**AGENDA  
CITY OF CEDAR FALLS, IOWA  
PLANNING AND ZONING COMMISSION MEETING  
WEDNESDAY, JANUARY 22, 2020  
5:30 PM AT CITY HALL**

2. **HWY-1 Site Plan Review – Residence Inn by Marriott**

**MEMORANDUM**  
*Planning & Community Services Division*

**TO:** Planning & Zoning Commission  
**FROM:** Jaydevsinh Atodaria (JD), Planner I  
**DATE:** January 13, 2020  
**SUBJECT:** Residence Inn Site Plan Review

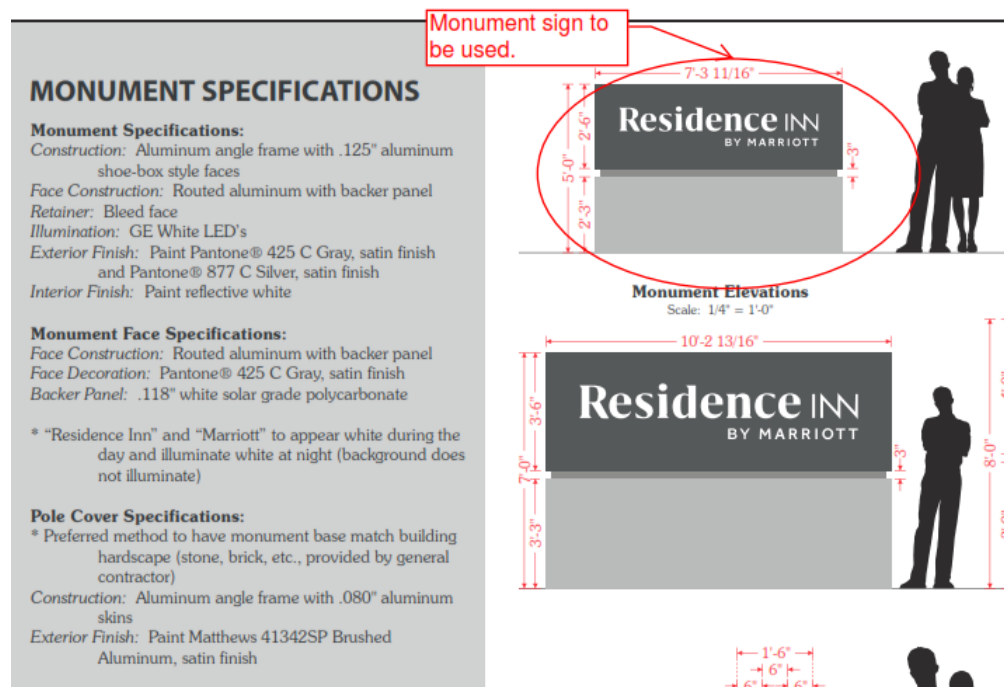
Architectural features of the new hotel building includes the one way sloping roofs on the ends of the main building and varying heights of the one way sloping roof in the entrance part of the hotel building. The one way sloping roofs are projecting the fascia boards creating a distinctive roof line for the entire building. These roof lines create a good balance between the flat roofs and pitched roofs used in the development of neighboring properties. There is also a unique light element designed for the hotel that will be located on west side façade of the hotel. Alternating projections in the floor plan will create several niches and will break the façade in rhythmic manner. Overall, the architectural style is more contemporary in nature and will help in developing a unique identity of the building.

- 7) **Trash Dumpster Site:** The dumpster enclosure for the new hotel is located at the northeast corner of the parking lot. This enclosure will be made of concrete block and will have two doors to operate towards the parking aisle. The enclosure will measure 14' by 14'. **Staff suggests that some detail about the height of the enclosure, type of color to be used be provided by the architect prior to approval by the Commission.**

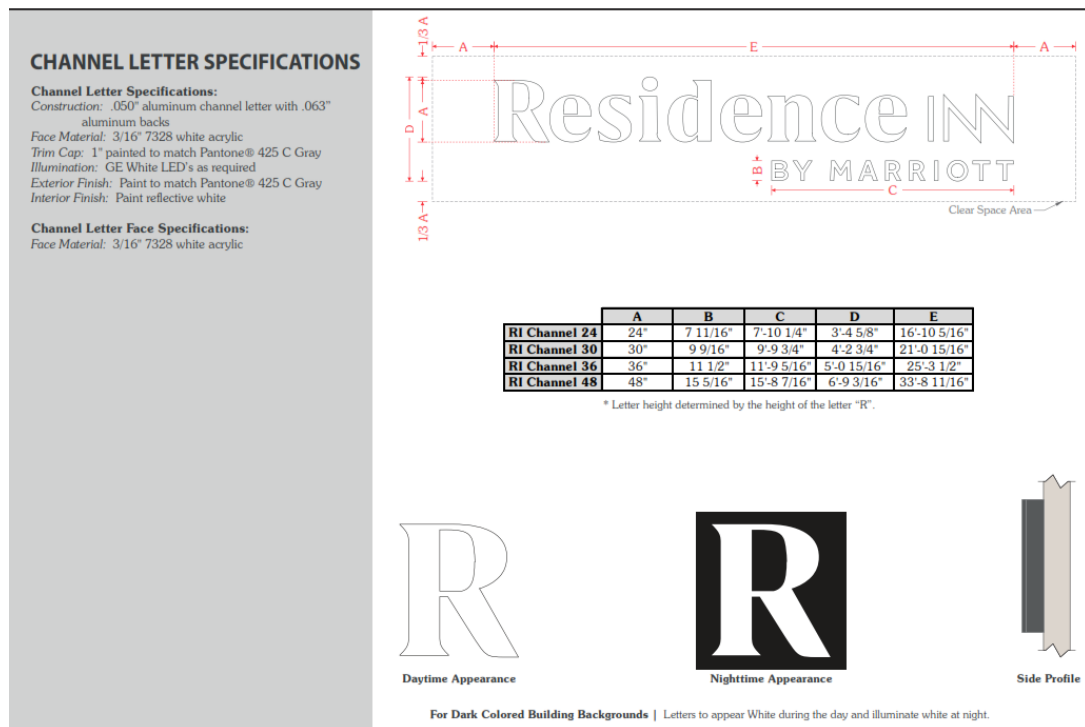
- 9) **Signage:** For the new hotel, two monument signs are illustrated on the site plan; at the entrance along Nordic Drive to the west of the building. These signs measure 5' tall by 7.3' wide. The monument signs will be made of aluminum angle frame with shoe box style faces. The monument sign will be illuminated by GE White LED's. The base of the monument sign will be made of aluminum angles and will be brushed with aluminum satin finished. The exterior face will be 425 C Gray satin finished. The letters on the monument sign will appear white during the day and will illuminate white at night. The proposed design of the monument base is darker so that the sign is visible from a distance and is clear. Please refer to the images below for more reference about the monument signs.

In addition, there are two wall signs, one facing the east and other facing the west. Channel letters will be used for the Wall Signs. Letters will be made with aluminum backs. Letters will appear Pantone 425 C gray during the daytime and will illuminate white at night. GE White LED's will be used for illumination of letters. Please refer to the images below for more reference about the wall signs. The proposed wall signs appear to be well within the District limitations of no larger than 20% of the wall area to which the wall sign is attached. However, this will be reviewed in detail at the time a sign permit is requested.

**Signage is acceptable, subject to detailed review with a sign permit.**
